TALLAWONG STATION **PRECINCT SOUTH**

ADDENDUM URBAN DESIGN REPORT

Rev. E_10.12.2020

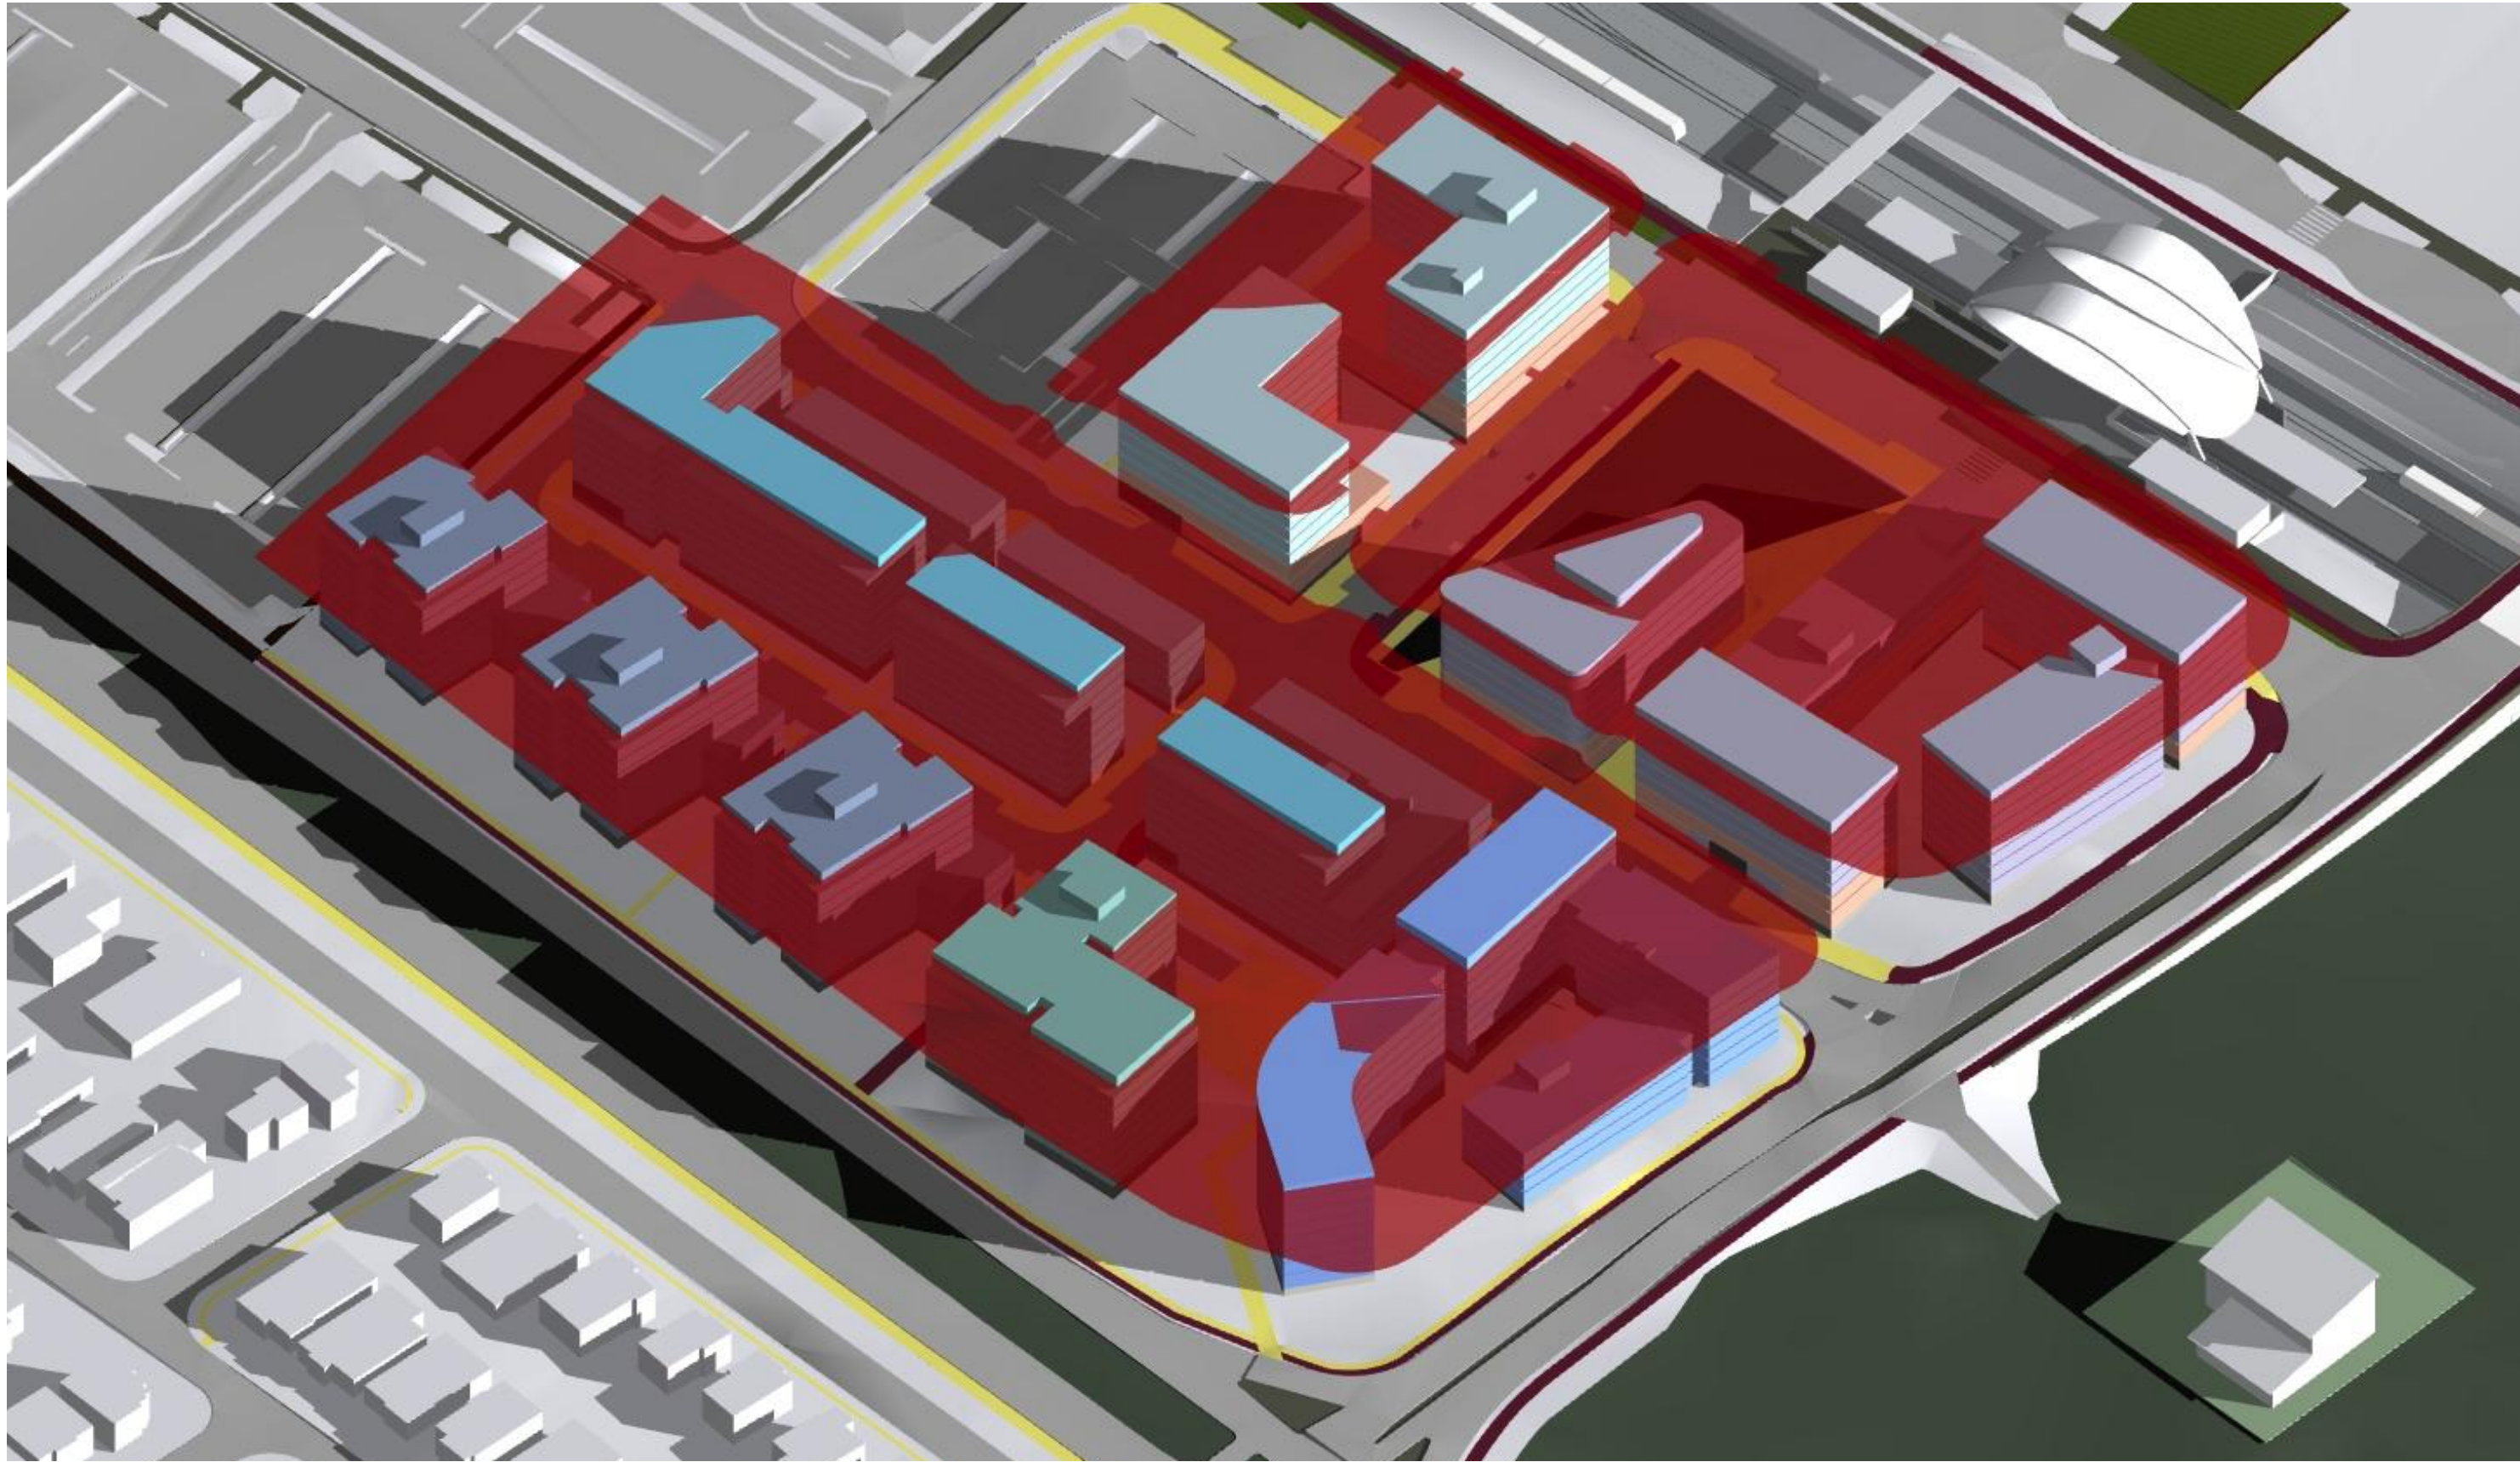
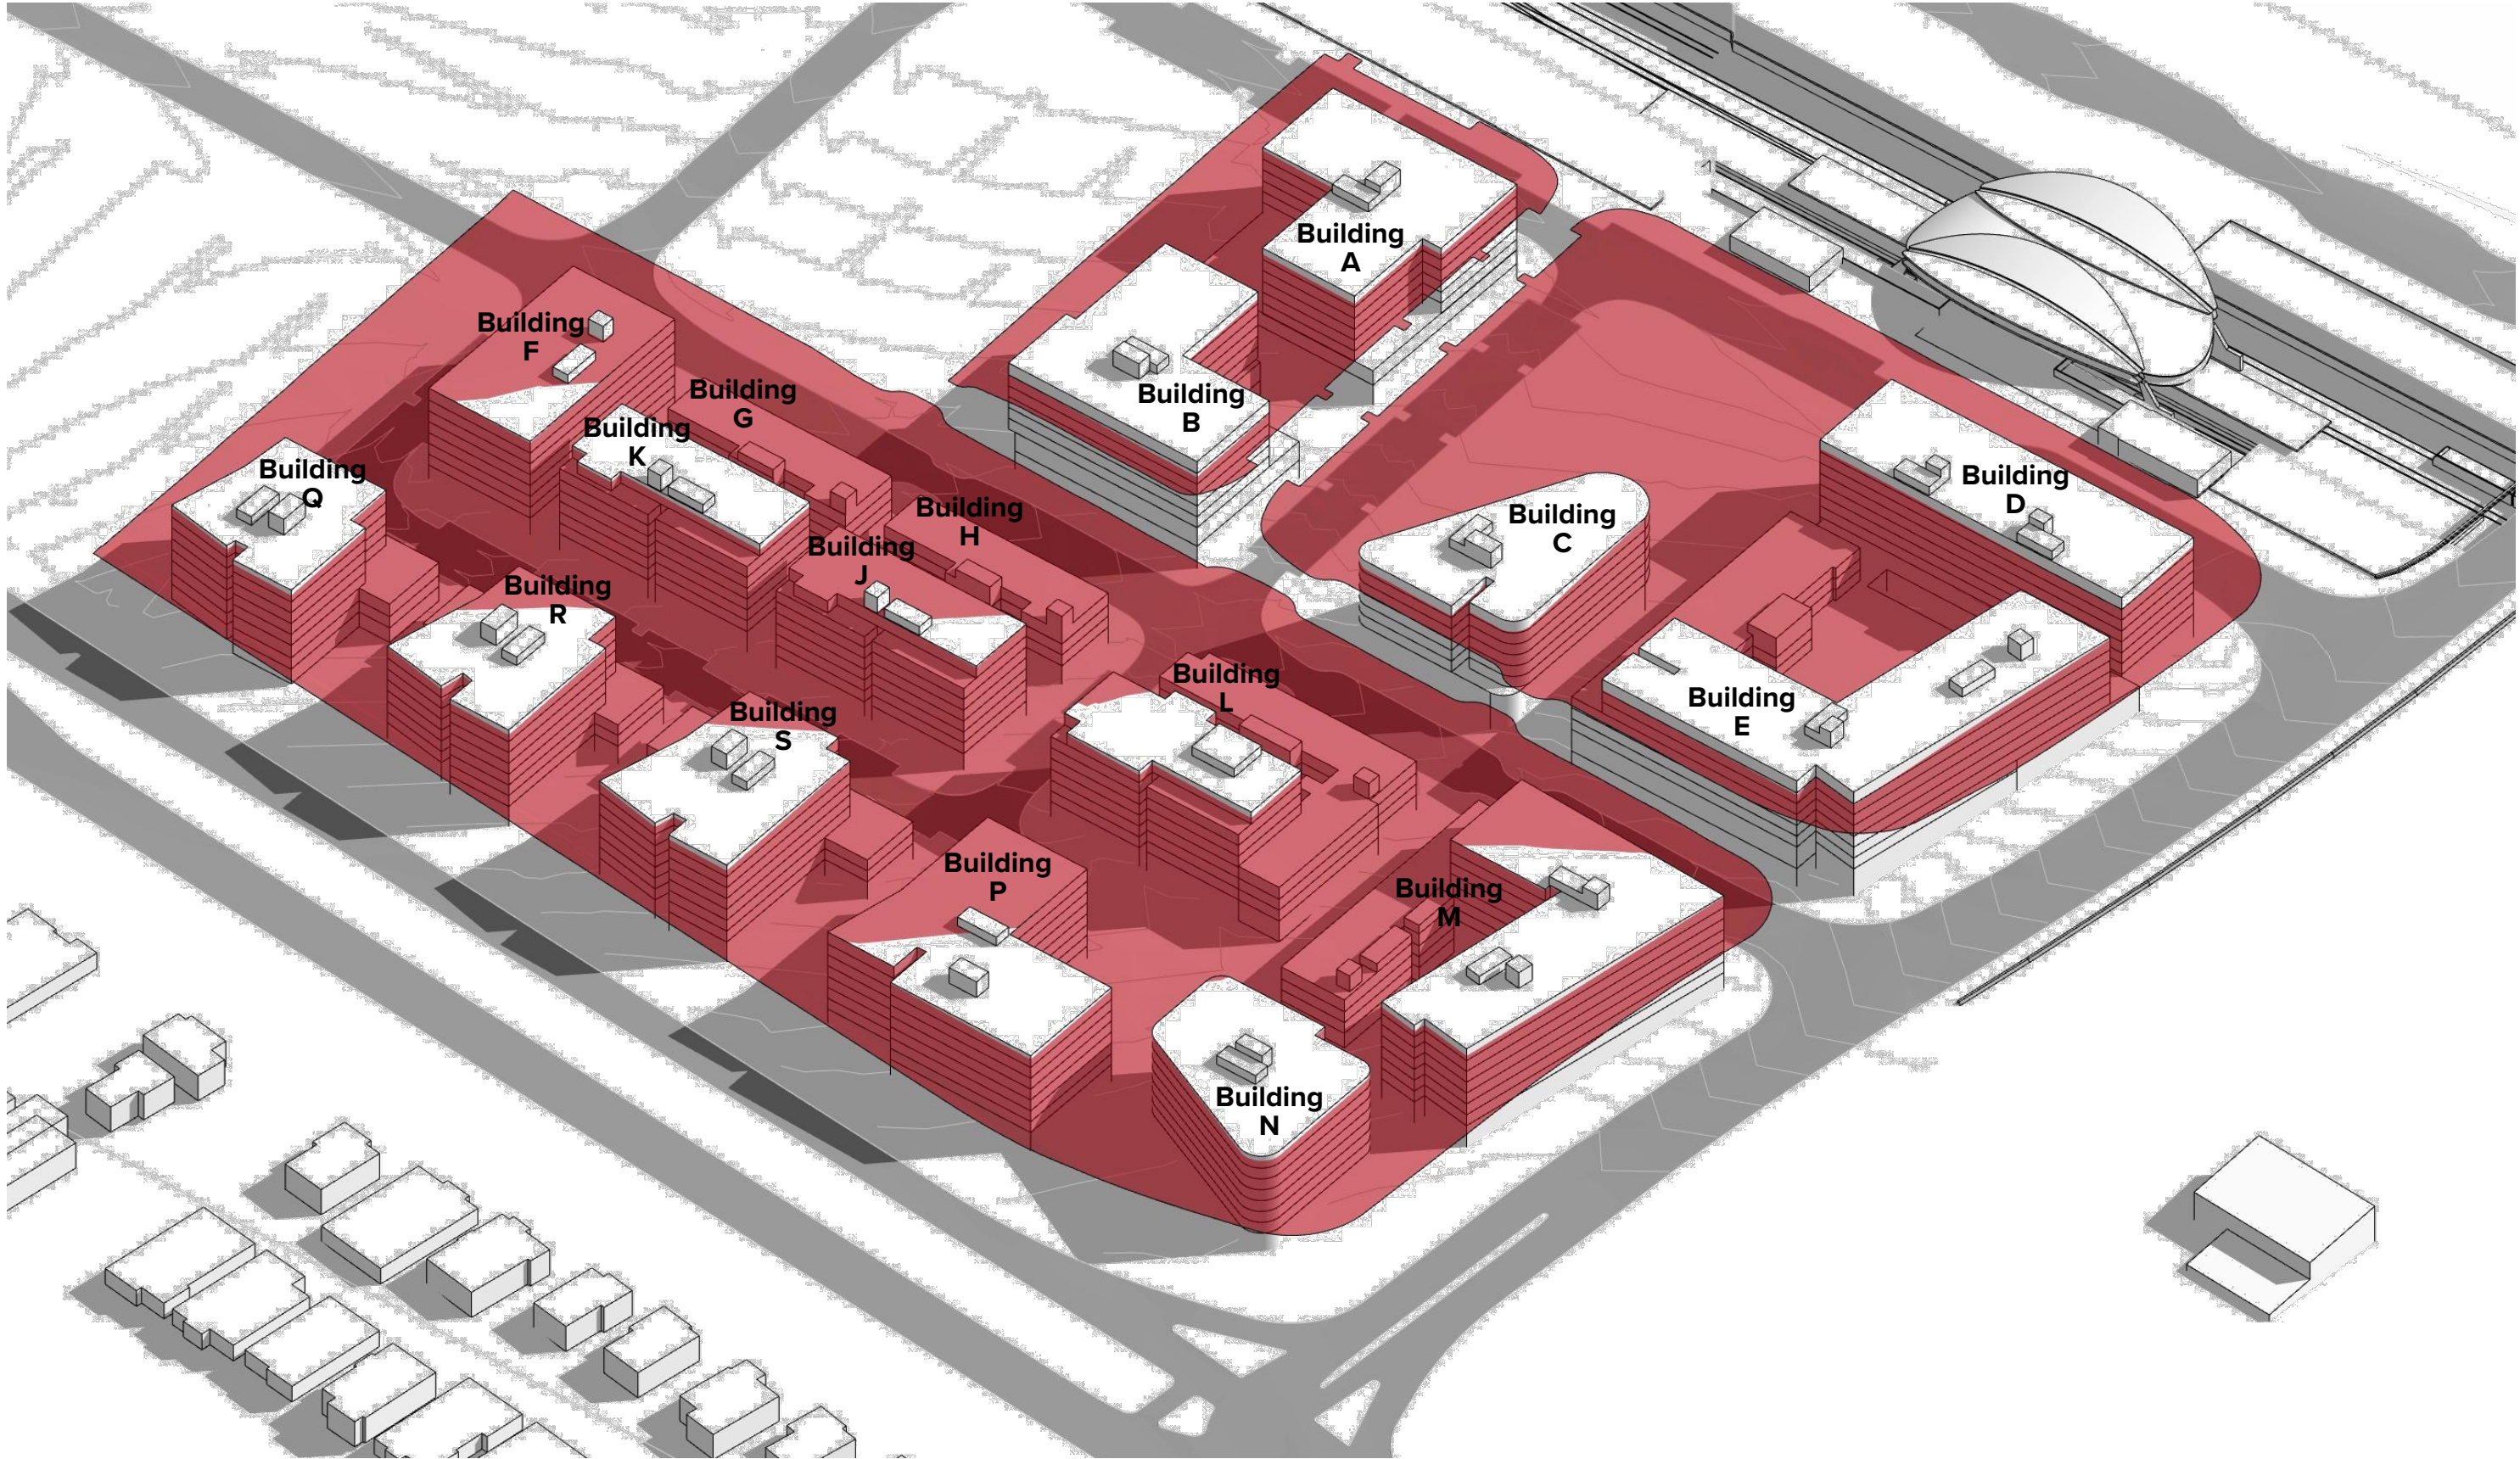
A comparison of the SSDA Approved Scheme and the Amended Proposal shows a minor increase in height to the north of the precinct in Site 1 (to accomodate flexible retail provision), while the buildings to the south of the precinct in Site 2 have a minor reduction in height.

AMENDED DEEP SOIL AND BASEMENT DIAGRAM

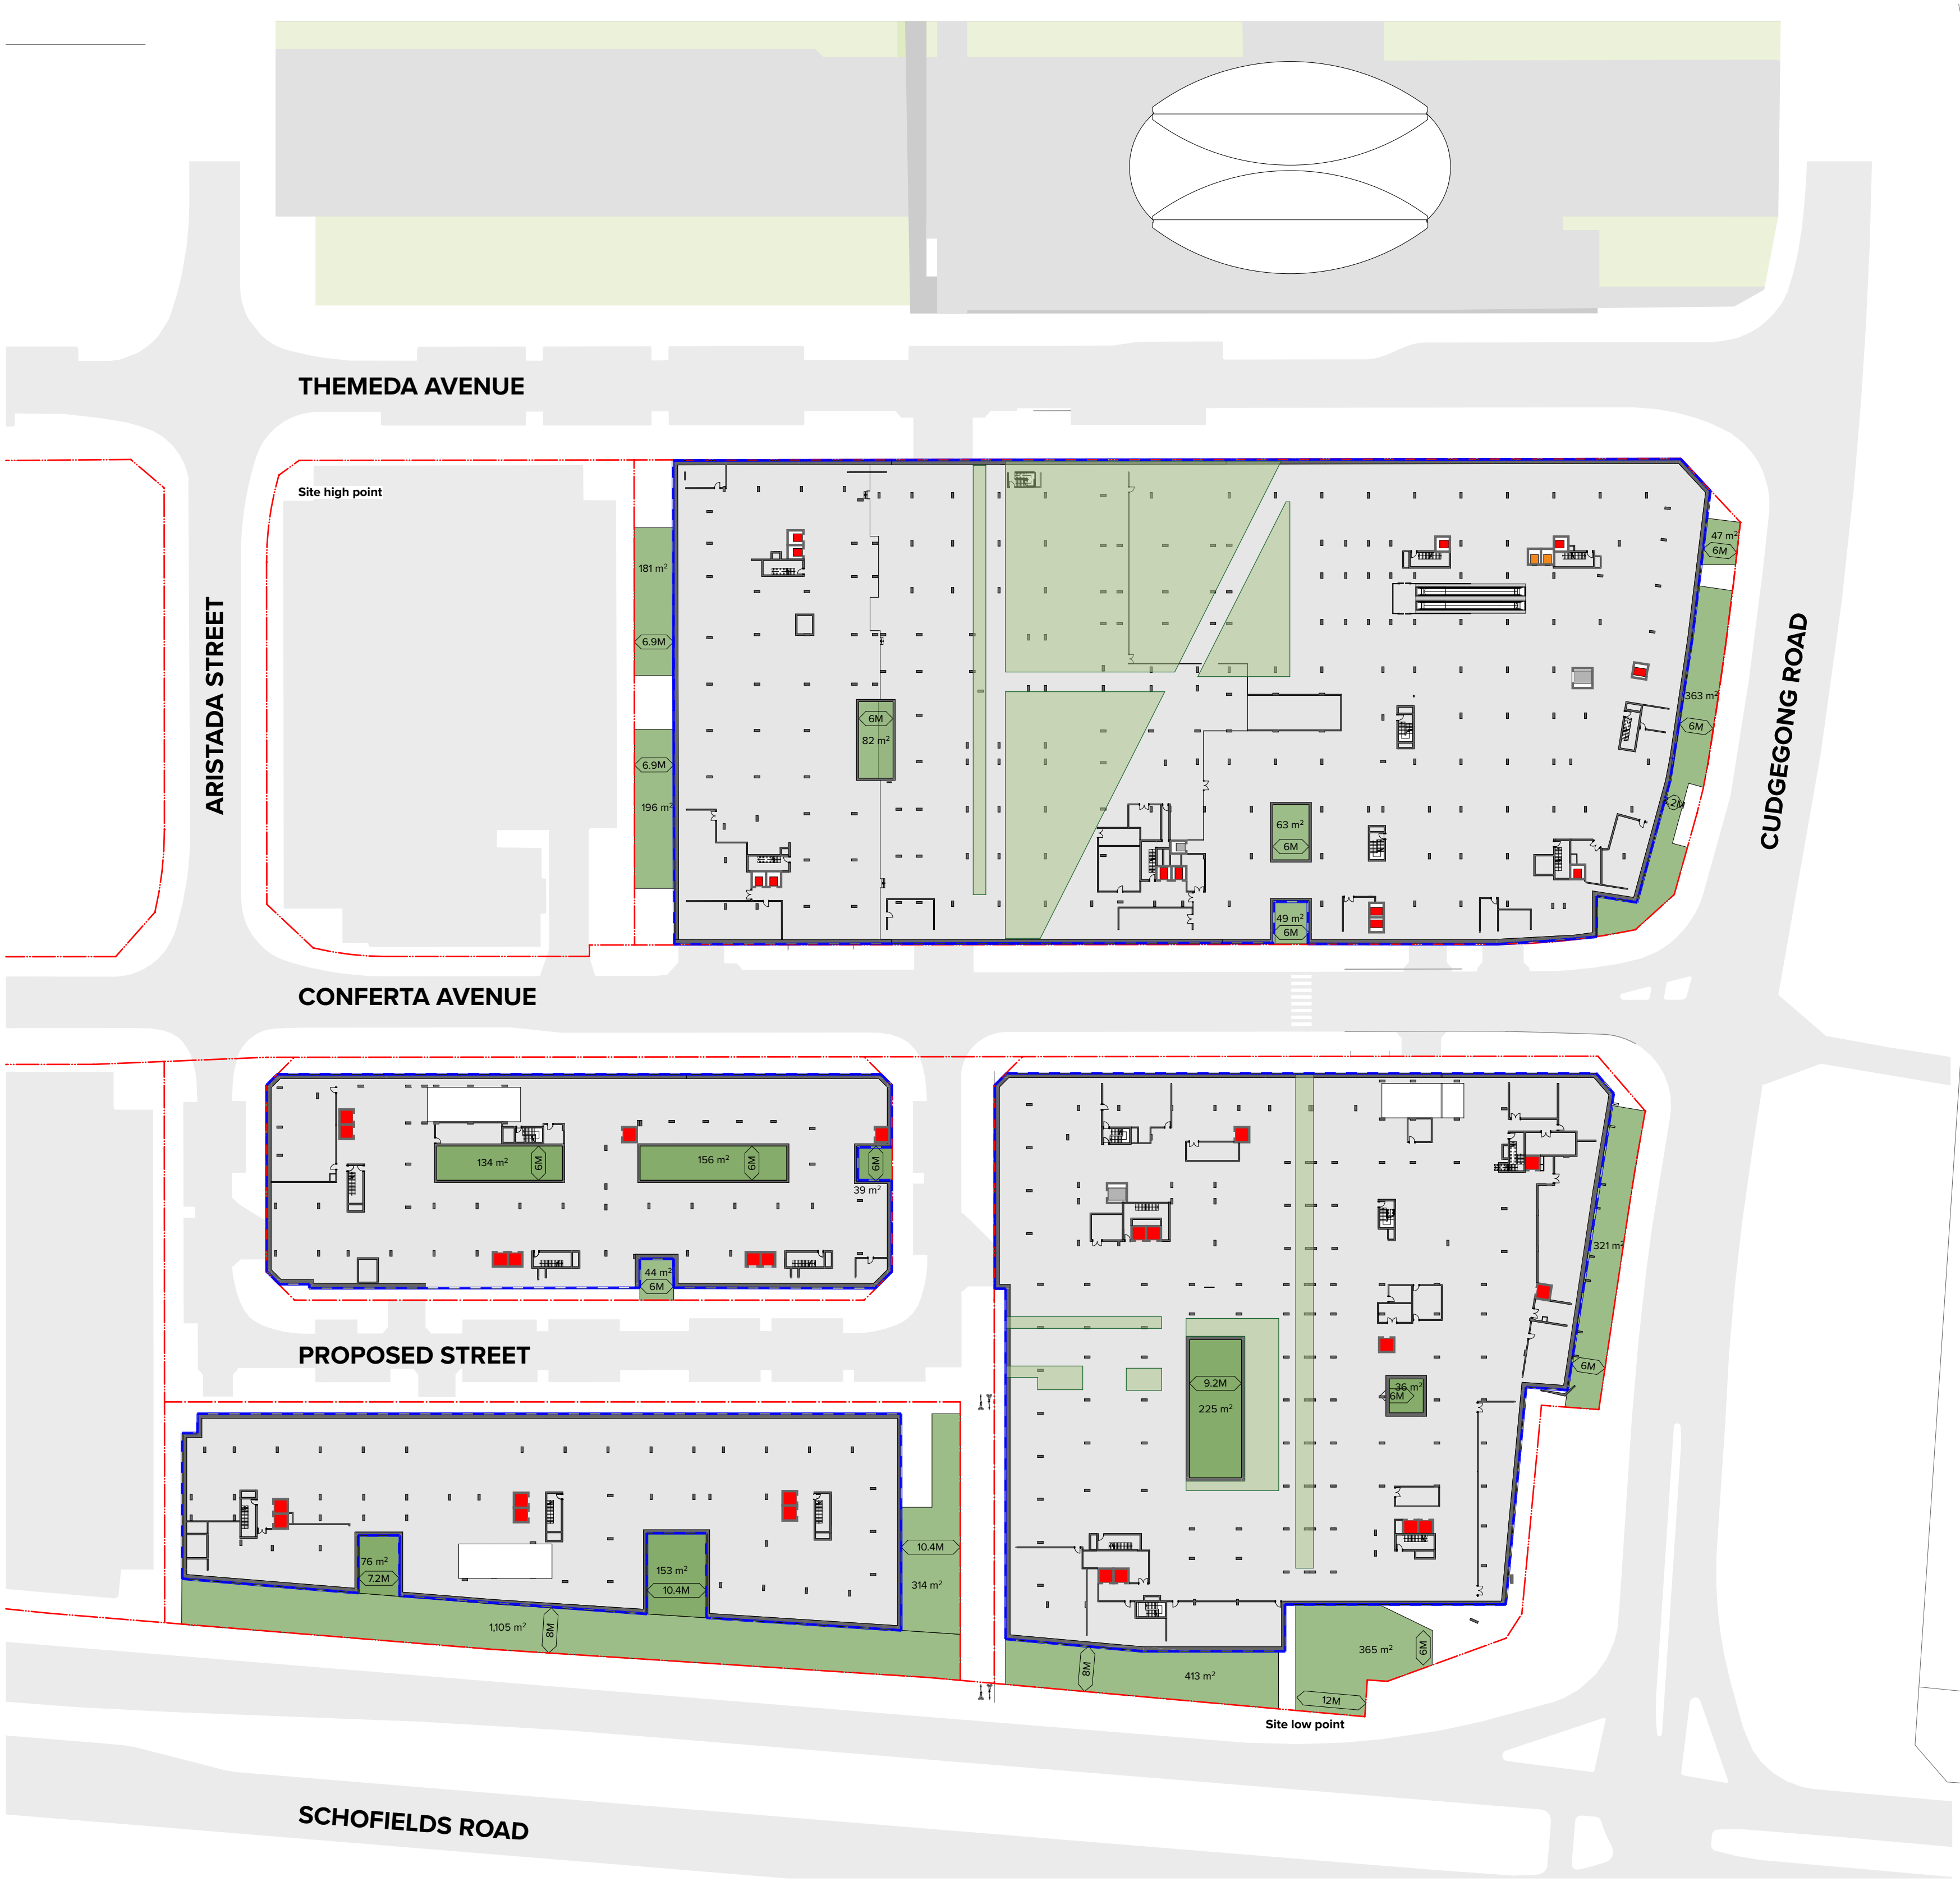
However, Council have resolved that they do not wish to take ownership of the park or the western adjacent street which is proposed to be designed as a private street. Accordingly, it is proposed that the park will be retained in private ownership and that public access of the park will be secured on title.

This provides the opportunity to extend the basement below the park which achieves a significant streetscape improvement as it facilitates the minimisation of the vehicle access points into Site 1A. In order to ensure that the park is still capable of supporting mature and generous trees and vegetation, a large soil 'vault' is proposed above the basement level with a minimum depth of 1.5 metres per detailed specialist consultant advice.
